IREDELL COUNTY HEALTH DEPARTMENT

IMPROVEMENT PERMIT / AUTHORIZATION TO CONSTRUCT / OPERATION PERMIT / EXISTING SYSTEM INSPECTION

PERMIT# 094800 PIN# 3795 53 2615 DATE 9-20-01

ADDRESS 757 NEW STERLING ROAD STONY POINT NC 28678

INITIAL SITE SKETCH ~ SCALE: 1" = 60'

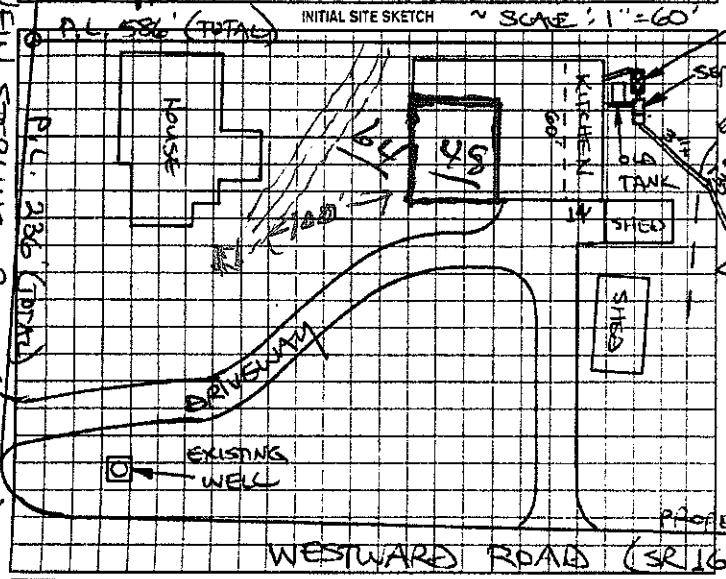
Comments/Conditions: ① INSTALL GREASE TRAP AT LOCATION SHOWN TO ACCEPT KITCHEN WASTEWATER ONLY. ② PLUMB BATHROOM WASTEWATER DIRECTLY INTO SEPTIC TANK. ③ COLLAPSE & BACKFILL EXISTING UNPERMITTED SEPTIC TANK

AS BUILT SKETCH

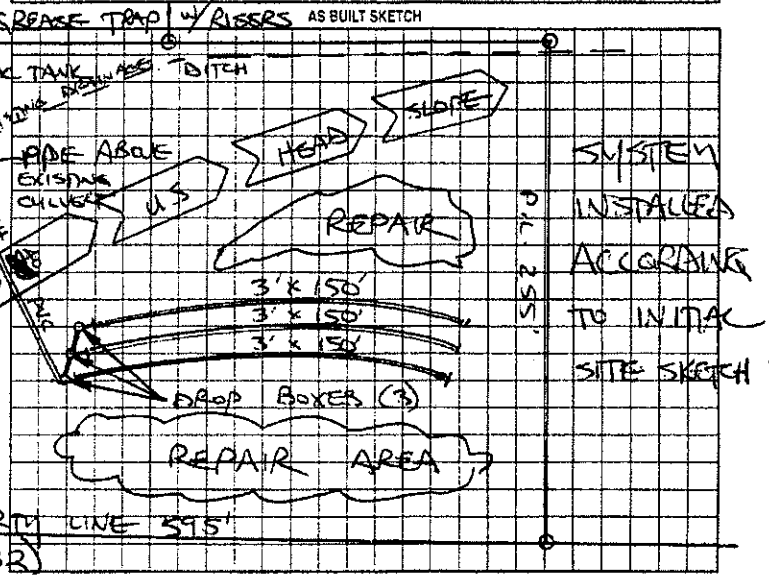
Comments Conditions: SEPTIC TANK W/ RISERS INSTALLED USING "POLYLOK" FILTER
